ADMINISTRATIVE AMENDMENT (PD) ADD2022-00161

ADMINISTRATIVE AMENDMENT
LEE COUNTY, FLORIDA

ITEC NORTHERN BASIN (TRACTS A-O-Q)

LAKE RELIEF REQUEST

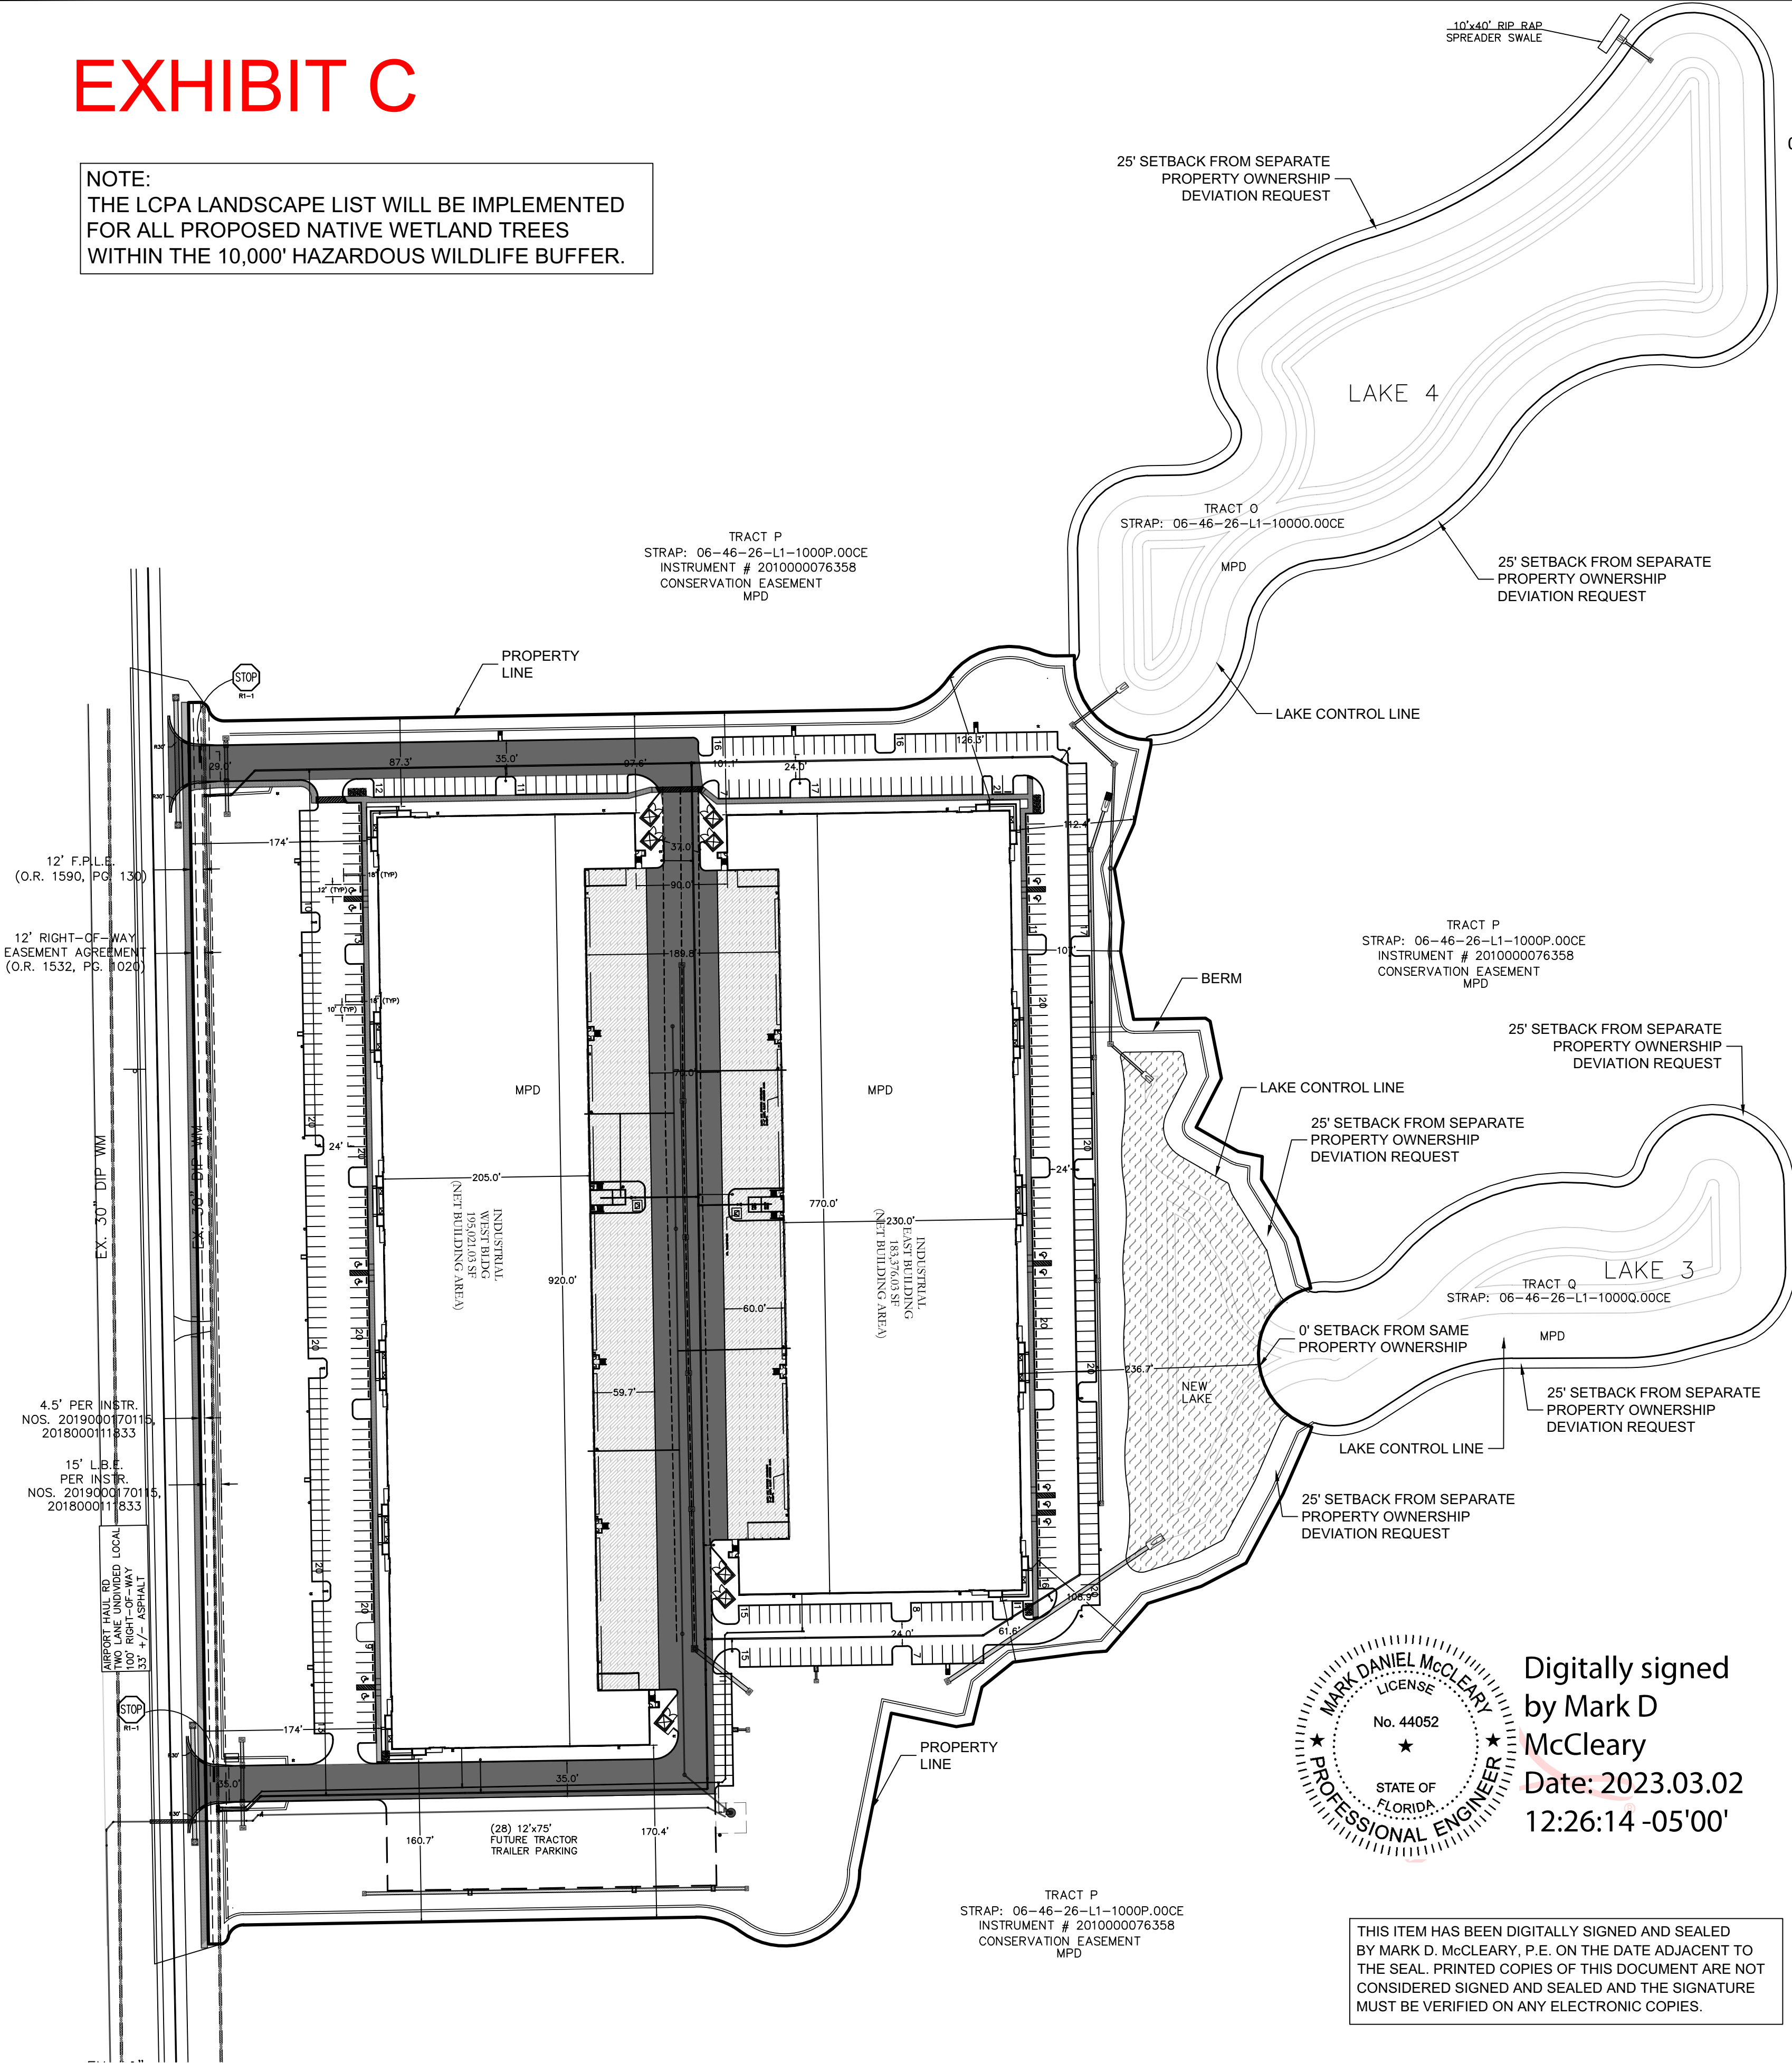
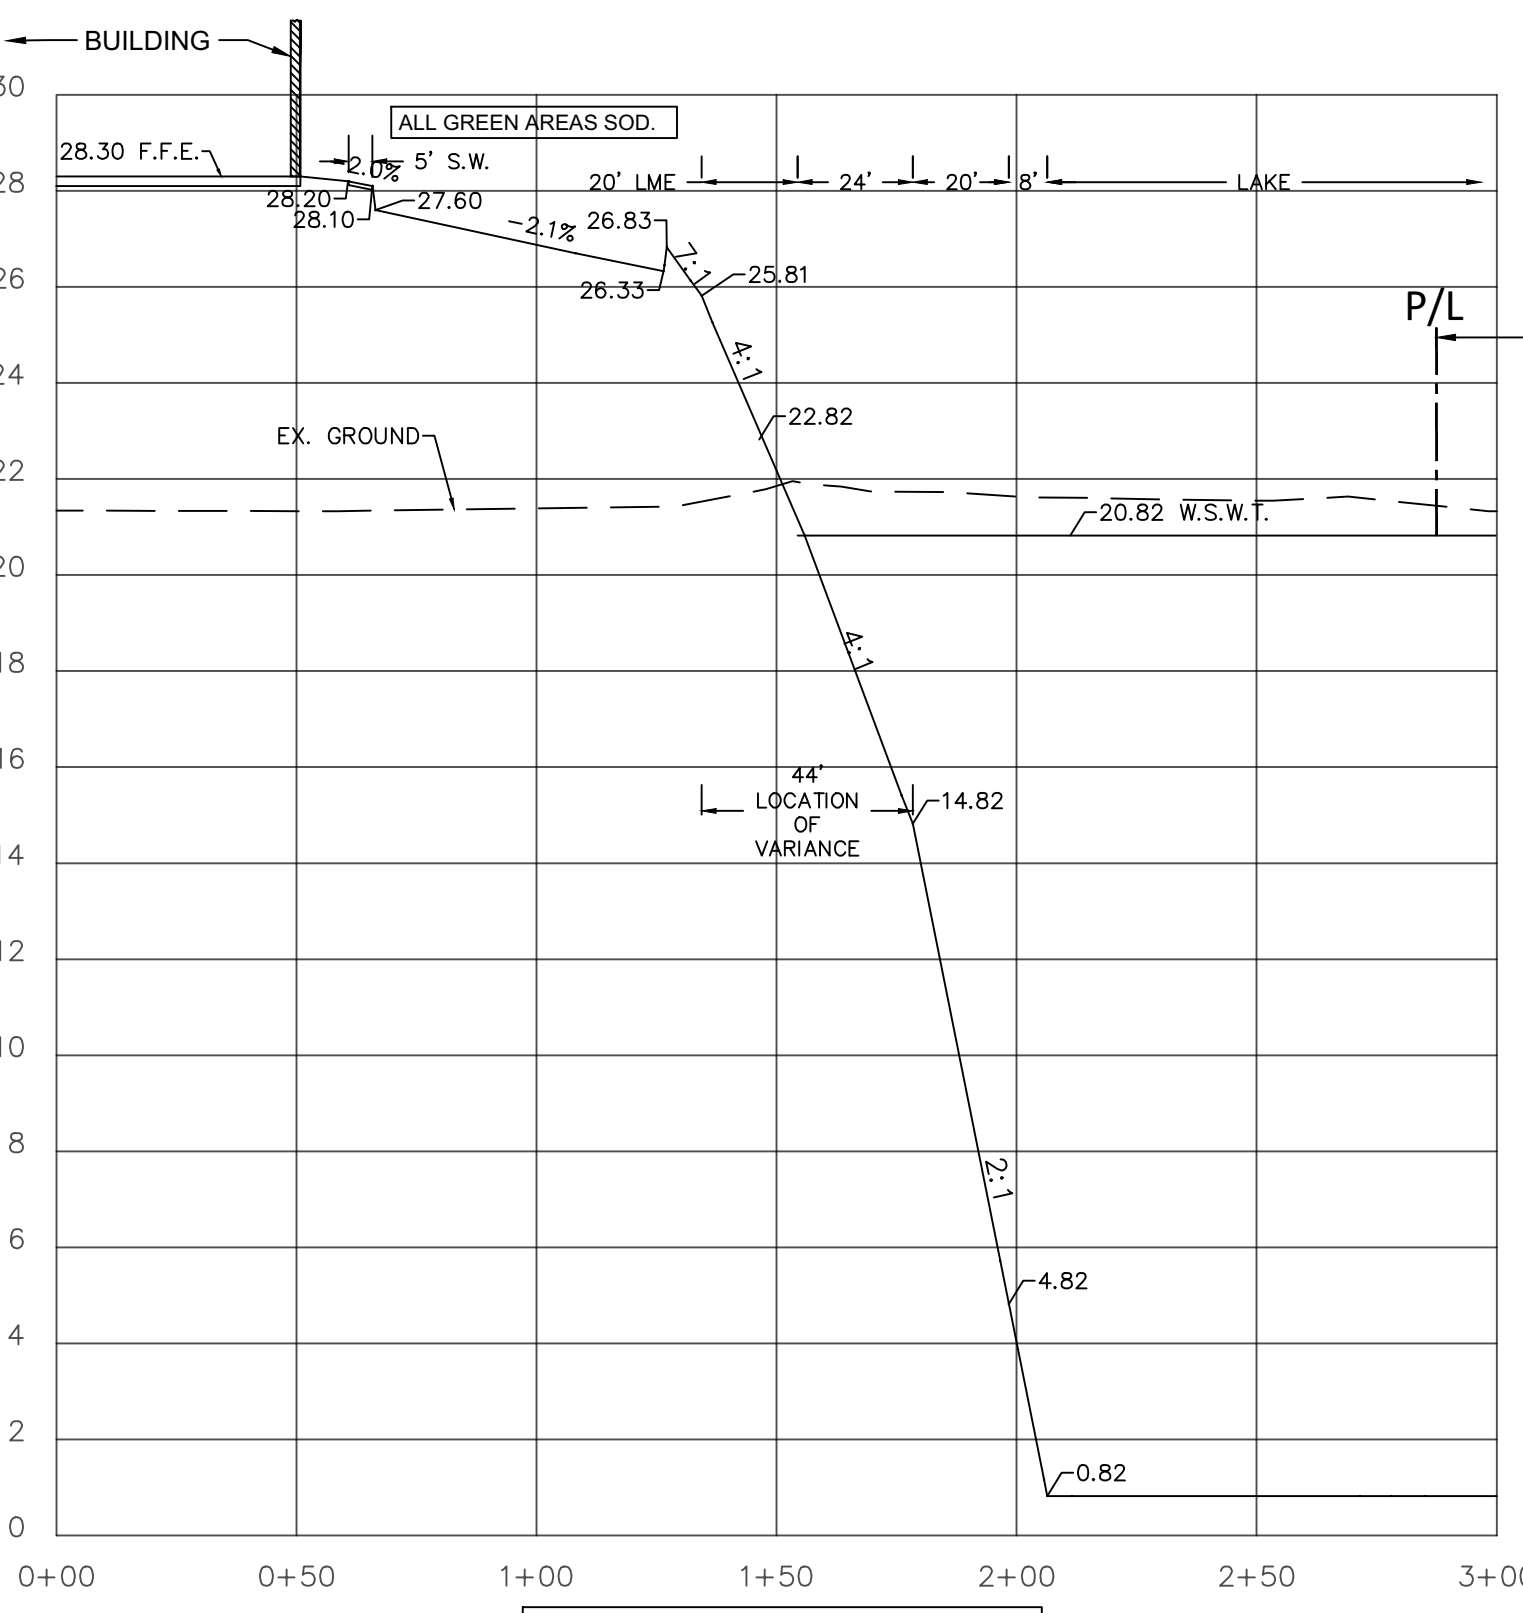
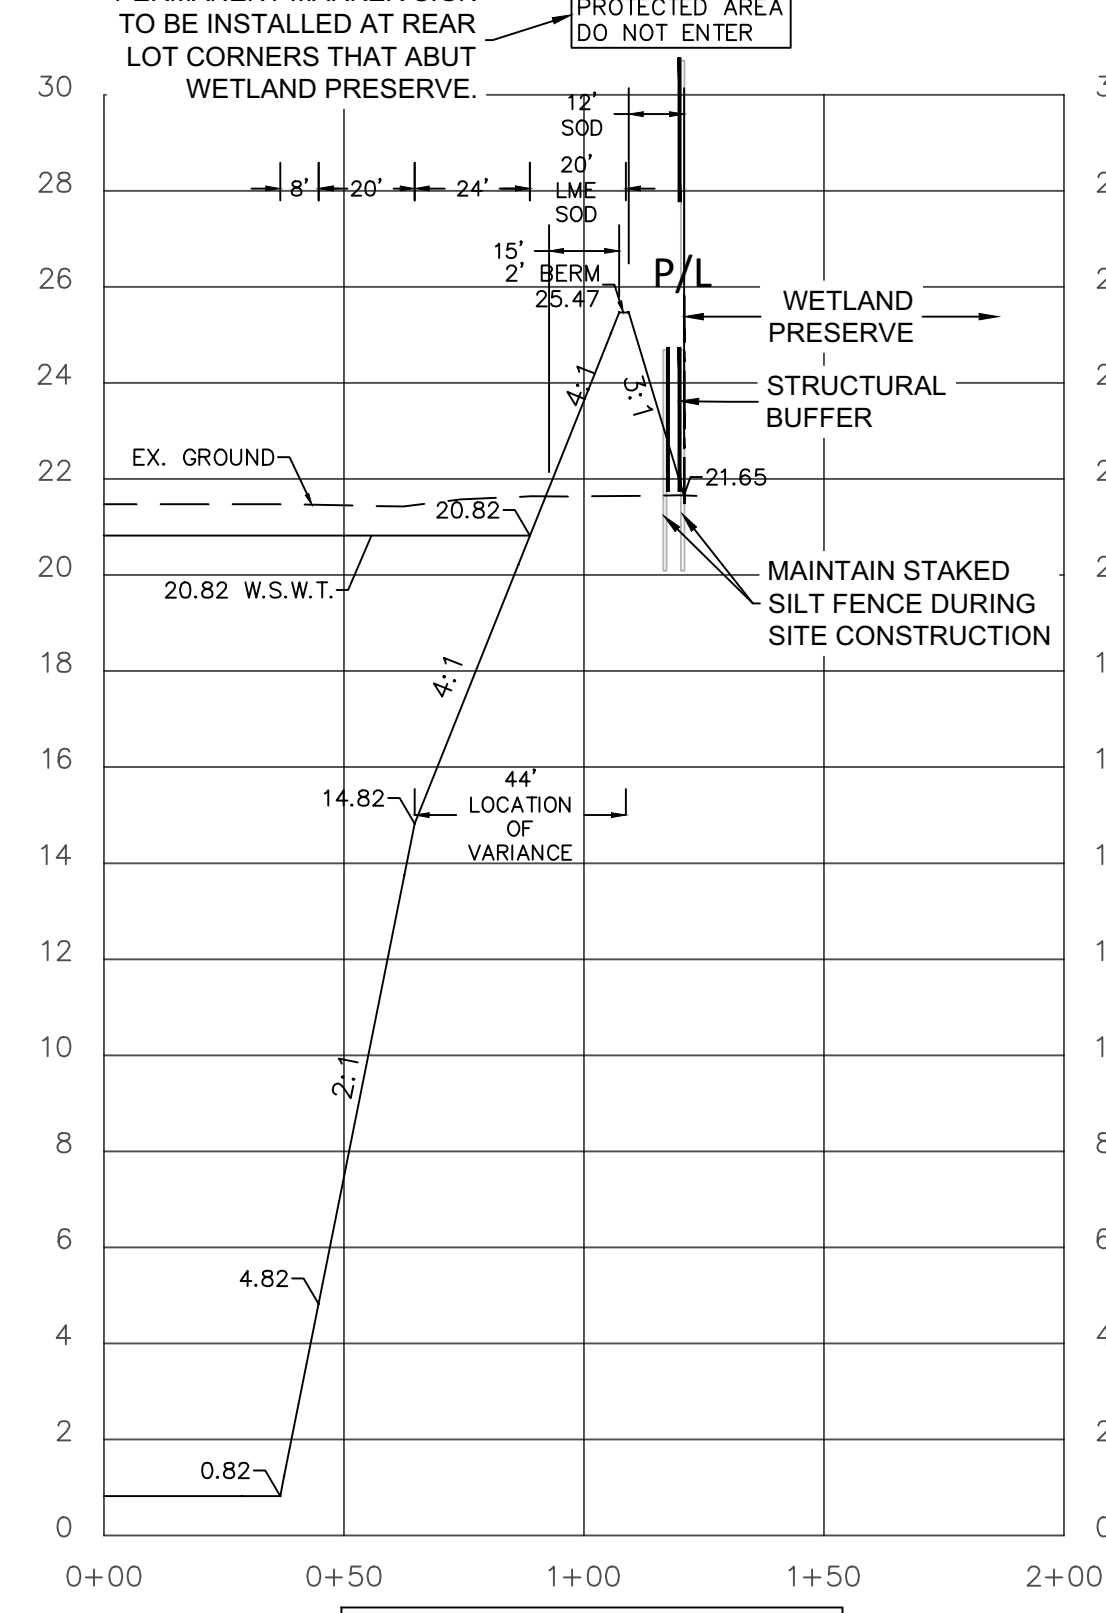
Variance Explanation:
The Lee County Land Development Code (see below) promotes flat lake bank slopes and littoral banks and plantings that are conducive for supporting wildlife in and around lakes. The flat littoral shelf and 6:1 lake bank allows for the aquatic wildlife to venture into this location and attract birds.
The relief sought is believed to be promoted by the Airport Authority when projects are this close to an airport as a safety measure. The distance from northernmost lake to the southern boundary of RSW is 1055 ft and from the southernmost lake is 2455 ft from the southern boundary of RSW. All are within the 5000 ft perimeter "A" where the separation distances within which hazardous wildlife attractants should be avoided, eliminated, or mitigated pursuant to the Advisory Circular- AC No: 150/5200-338, published by U.S. Department of Transportation Federal Aviation Administration regarding HAZARDOUS WILDLIFE ATTRACTANTS ON OR NEAR AIRPORTS.

This project is directly south of RSW airport. Any condition or circumstance that causes bird attraction near airport can prove fatal to the traveling public.
The requests are to steepen the lake banks slopes as indicated in Sec. 10-329 - Excavations (d) Standard, (4) Bank Slopes required for the Planned littoral shelf (PLS) are in effort to reduce the attraction of birds, improve safety and promote water quality.
The relief sought to reduce the lake setback in LDC 10-329(d)(1)(a)(3) from 50' to 25' adjacent to Tract P as originally approved and partially constructed by the original developer, but documentation of same has not been found to date.

Considerations:
The project being located near RSW airport is the reason for this variance request and not the result of the landowner's actions. The variance will relieve the burden caused by the land development requirements. The granting of the variance will not be injurious to the neighborhood or detrimental to the public welfare. The variance is consistent with the Lee Plan.

2. Prior to development order, plans must depict lakes sloped no less than four horizontal to one vertical from the top of bank to a water depth of two feet below the dry season water table.

3. Prior to development order, landscape plans must depict 100 percent substitution of required littoral plantings with native wetland trees within the littoral shelves surrounding the lakes.

4. Prior to development order, plans must depict a minimum setback of 25 feet from the private property boundary to the east.
5. The terms and conditions of the original zoning resolution and subsequent amendments thereto remain in full force and effect, except as amended herein.
